LINDSAY'S ORCHARD ADDITION

Re: S/D 97-37 - Final Plat of LINDSAY'S ORCHARD

Re: S/D 97-37 - Final Plat of LINDSAY'S ORCHARD

CASE NUMBER: S/D 97-37 - LINDSAY'S ORCHARD ADDITION

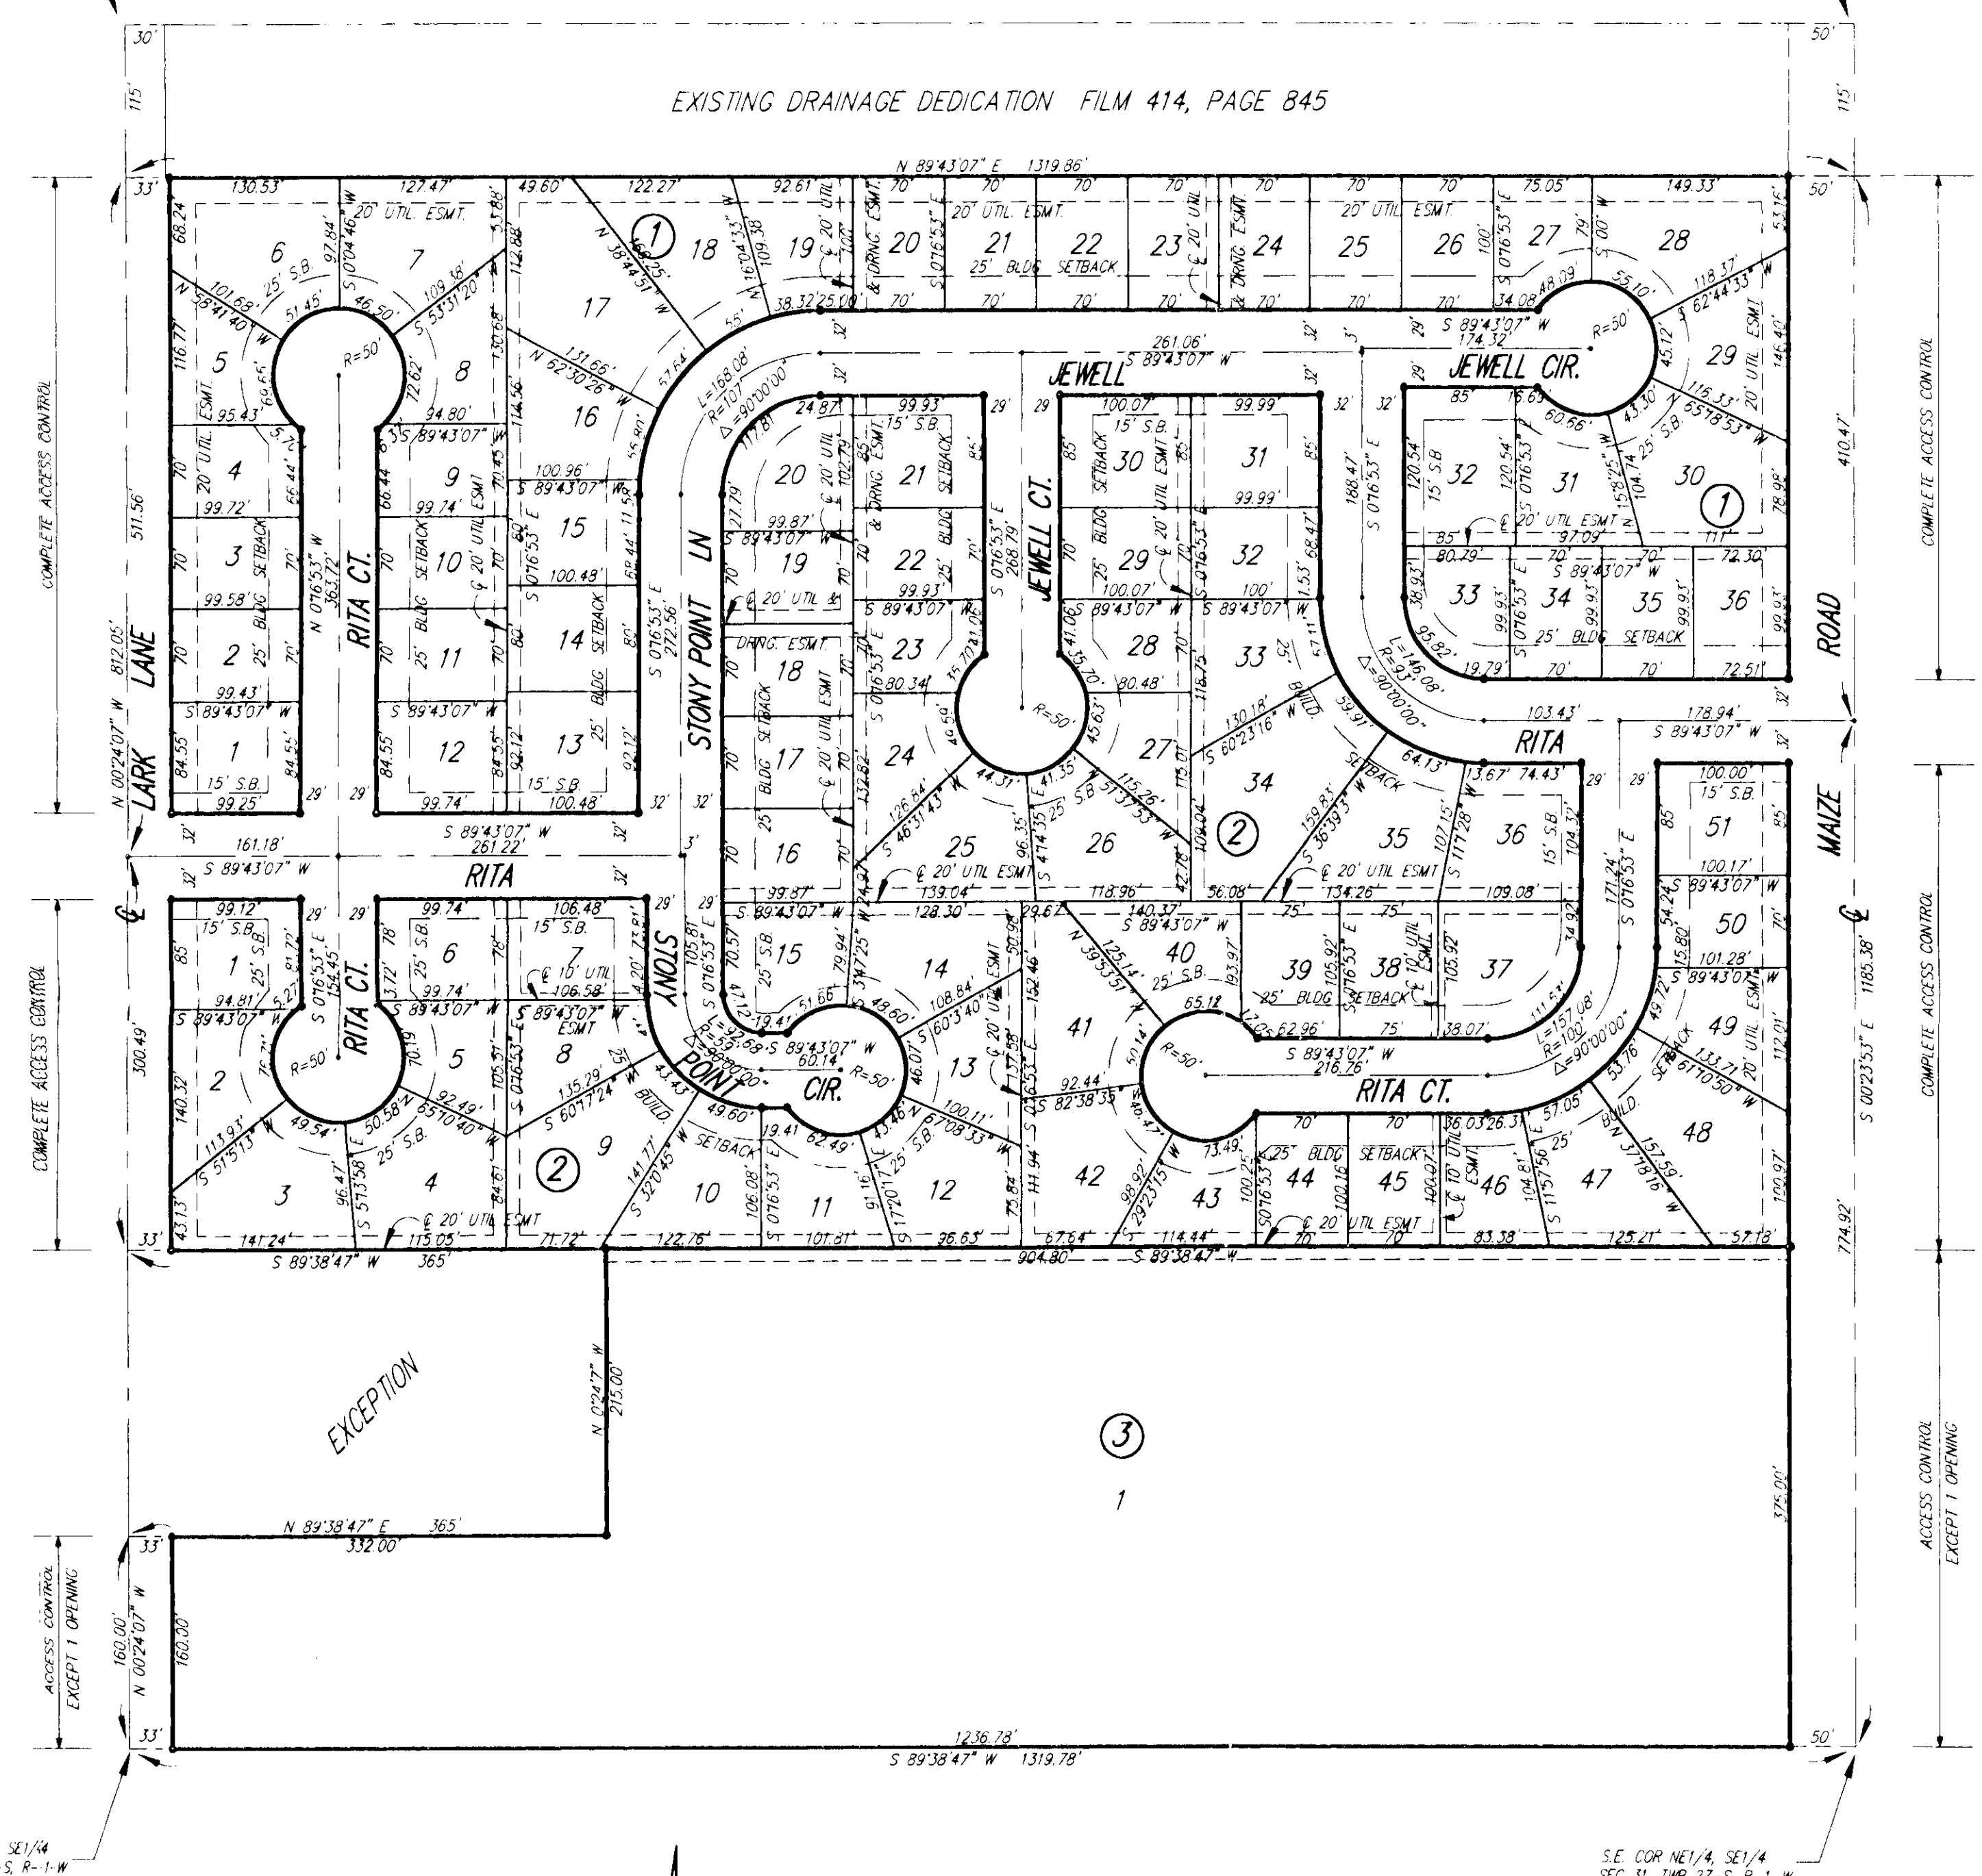
Access Control for Lot 1, Block 3 to Maize Road should be provided. Complete access should be granted for the residential lots along Maize.

- D. Sidewalks should be provided on one side along Rita, Stony Point Ln, and Jewell.
- E. The applicant shall guarantee the construction of any drainage improvements required by the platting of this property, including storm sewers. Minimum pad elevations should be established on the lots near the drainage ditch. City Engineering requests drainage improvements be guaranteed. The drainage plan has been approved.
- F. If improvements are guaranteed by petition, a notarized certificate listing the petitions shall be submitted to the Planning Department for recording.
- G. A covenant providing for 4 off-street parking spaces per dwelling unit shall be provided as

- H. Representatives from the City Fire Department comment that the street name "Fieldcrest" should be changed to "Rita".
- I. City Engineering indicates that the applicant's drainage concept has been approved.

Access Control for Lot 1, Block 3 to Maize Road should be provided. Complete access should be granted for the residential lots along Maize.
- D. Sidewalks should be provided on one side along Rita, Stony Point Ln, and Jewell.

- E. The applicant shall guarantee the construction of any drainage improvements required by the platting of this property, including storm sewers. Minimum pad elevations should be established on the lots near the drainage ditch. City Engineering requests drainage improvements be guaranteed. The drainage plan has been approved.

- H. Representatives from the City Fire Department comment that the street name "Fieldcrest" should be changed to "Rita".
- I. City Engineering indicates that the applicant's drainage concept has been approved.
